CALIFORNIA COASTAL COMMISSION

ADDENDUM

DATE: May 9, 2011
TO: Commissioners and Interested Parties
FROM: South Central Coast District Staff
SUBJECT: Agenda Item 21b, Thursday, May 12, 2011, Coastal Development Permit Application 4-10-036 (California Department of Parks and Recreation)

Re: Application #4-10-036
Nicholas Pond Trail/Leo Carrillo State Park – URGENT

EXHIBIT 10
Permit 4-10-036
Pond Overlook Plan

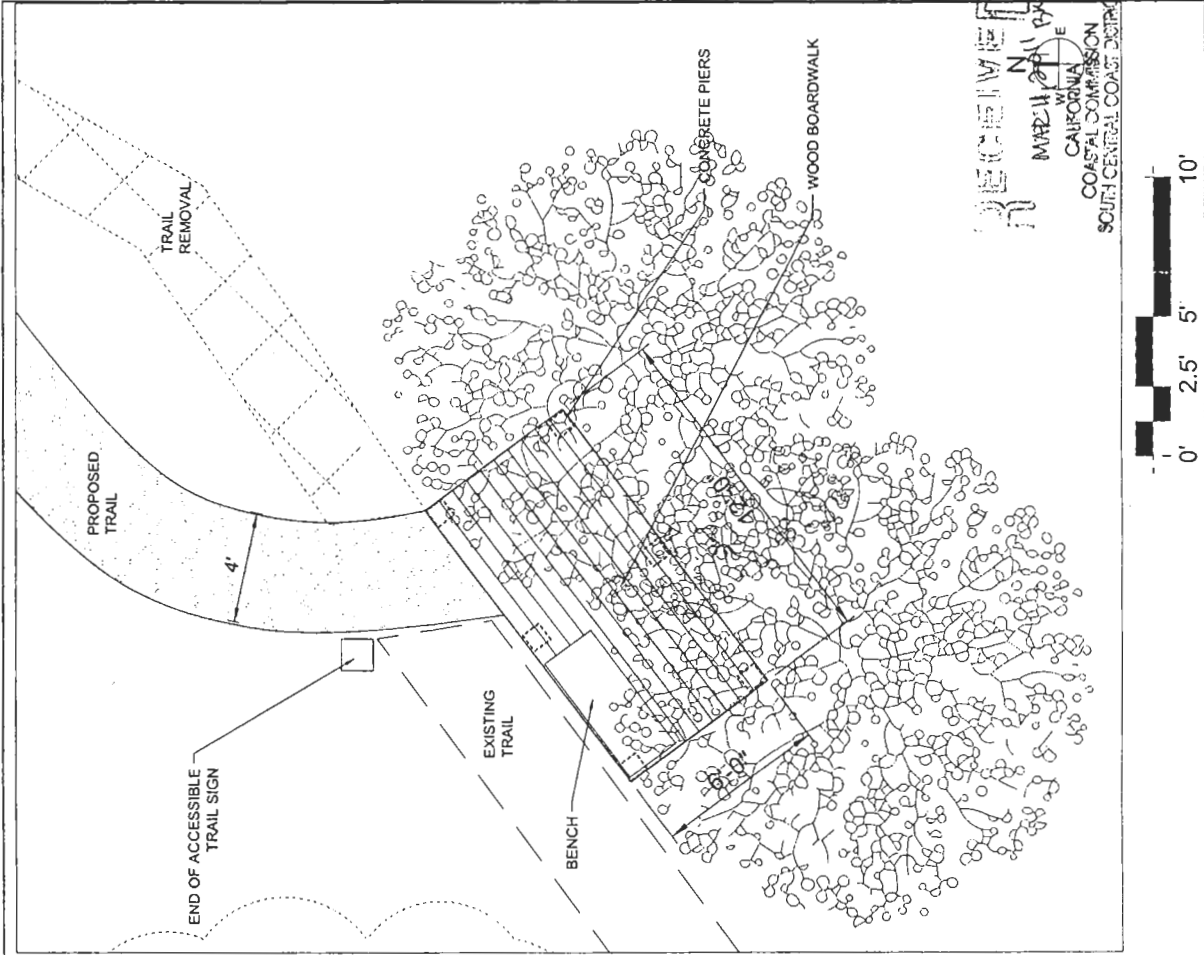
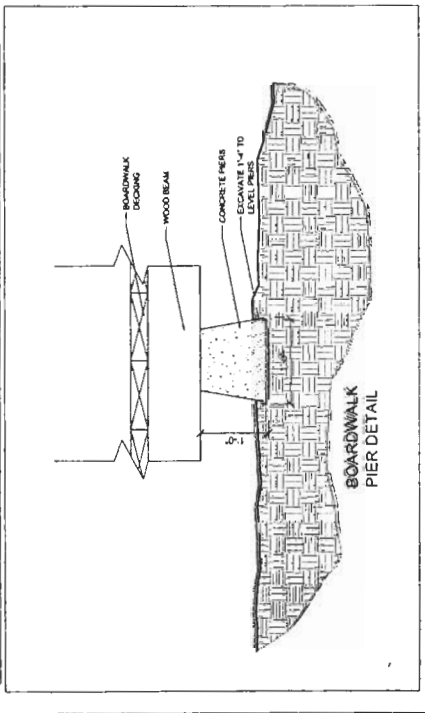
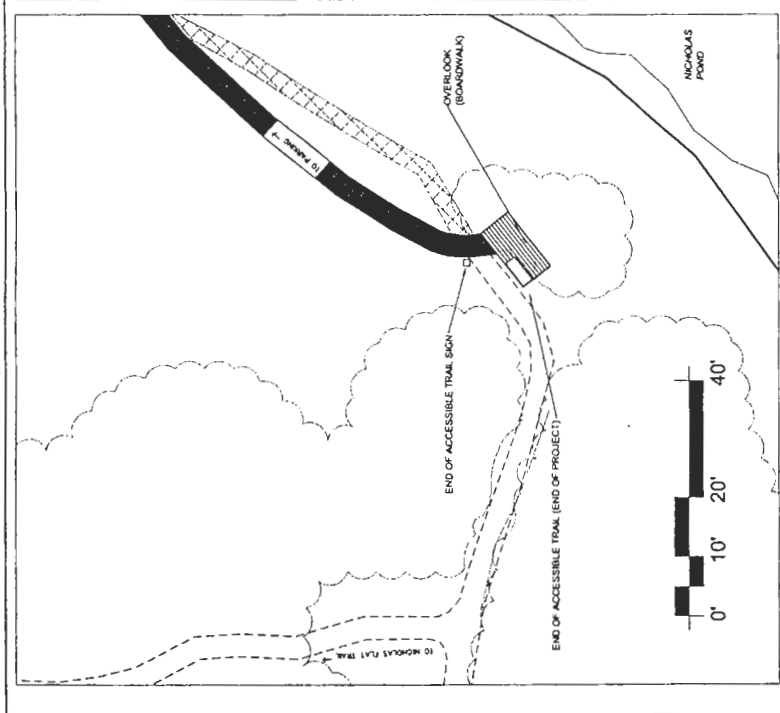
3. The Project Description shall be revised to clarify the originally proposed pond overlook and the subsequent changes made by the applicant to minimize adverse impacts.

The "Pond Overlook" section of the Project Description on page 11 shall be revised as follows:

Pond Overlook: Construction of a 72 sq. ft. pond overlook on the southwest edge of Nicholas Pond to meet ADA standards. An informal overlook area already exists here in the shade of several oak trees, which has resulted in the compaction of the soil within the oak protected zones. Originally, the applicant proposed a 354 sq. ft. pond overlook consisting of a graded flat pad and a 2 ft. high rock retaining wall within the canopy of several oak trees. At the request of staff, Sseveral alternatives were considered by the applicant to avoid surface disturbance within the oak canopy/dripline. Due to visitor safety concerns, construction and maintenance limitations, and budget restrictions, the applicant proposes to construct the overlook in its originally proposed location, but has altered the design. However, at the request of staff, the applicant has revised the proposed project to construct a raised permeable wooden deck platform which will avoid the need for any grading or landform alteration, decrease the size, and delete the retaining wall to minimize impacts to the adjacent oak trees. As proposed, the deck overlook design would minimize potential impacts to the oak root systems by being elevated off the ground and limiting total surface disturbance to six small piers (Exhibit 10). Additional mitigation measures will be employed during construction to avoid impacts.

The first paragraph on page 20 of the staff report shall be revised as follows:

Construction activities at the pond overlook will also encroach into the canopy/dripline of two oak trees; however, the applicant has modified the design of the overlook to minimize impacts to the oak trees. Originally, the applicant proposed a 354 sq. ft. pond overlook consisting of a graded flat pad and a 2 ft. high rock retaining wall within an oak canopy. Sseveral alternatives were considered by the applicant to avoid surface disturbance within the oak canopy/dripline. Due to visitor safety concerns, construction and maintenance limitations, and budget restrictions, the applicant proposes to construct the overlook in its originally proposed location, but However, at the request of staff, the applicant has changed the proposed project to utilize a raised permeable wooden deck platform which will avoid the need for any grading or landform alteration, decrease the size, delete the retaining wall, and has altered the design to minimize impacts to the adjacent oak trees.

EXHIBIT 12
Permit 4-10-036
Potential Tree Removals

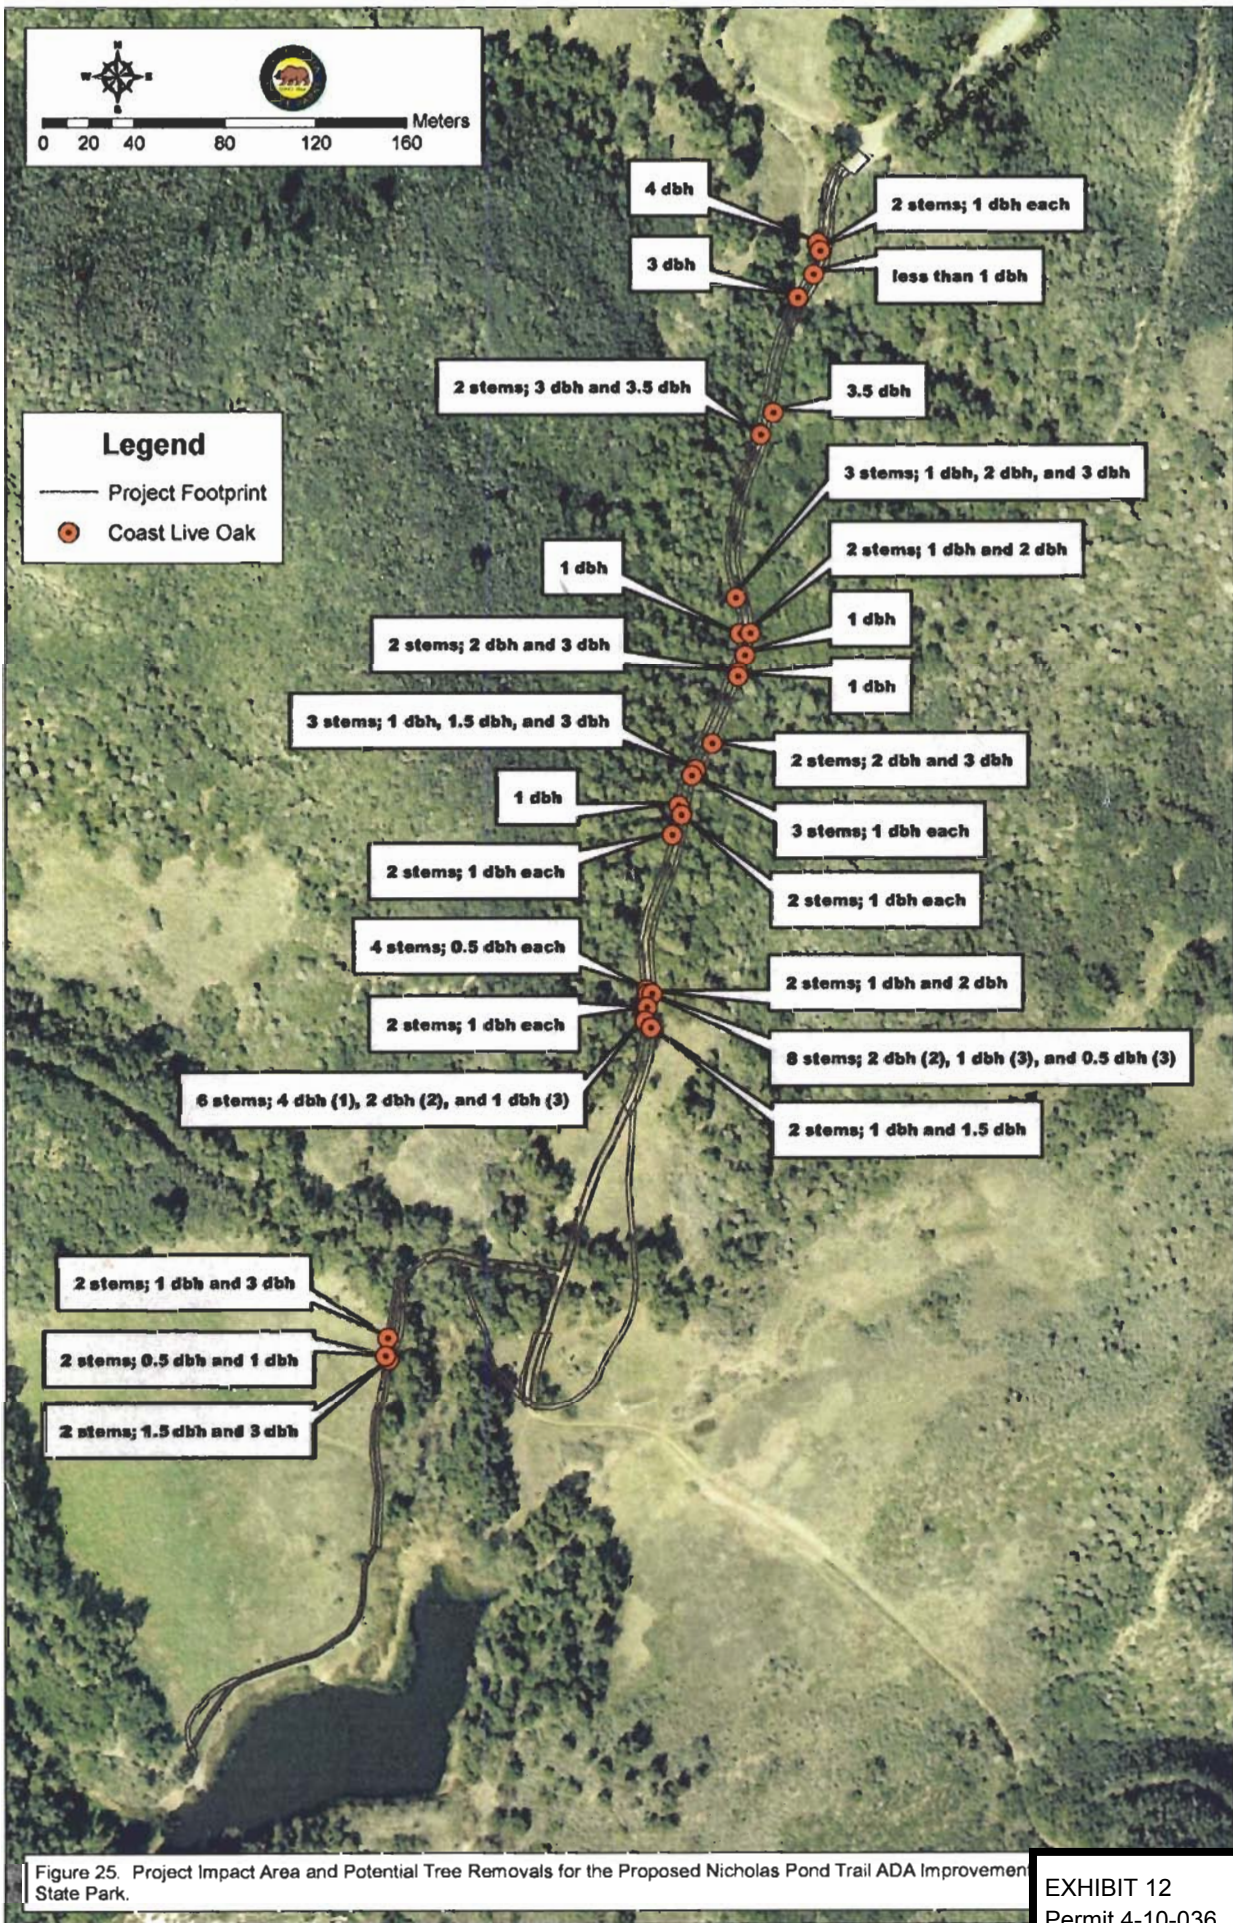
2. The staff report shall be revised to clarify that oak saplings will be transplanted. Pages 11, 16, and 19 of the staff report shall be revised as follows:

As part of the project, trees and shrubs within project limits will be avoided, to the maximum extent practicable, or salvaged for later use. Approximately 27 coast live oak saplings ranging in size from ½ inch to 4 inches diameter breast height (DBH) could potentially be ~~removed and/or~~ transplanted (Exhibit 12).
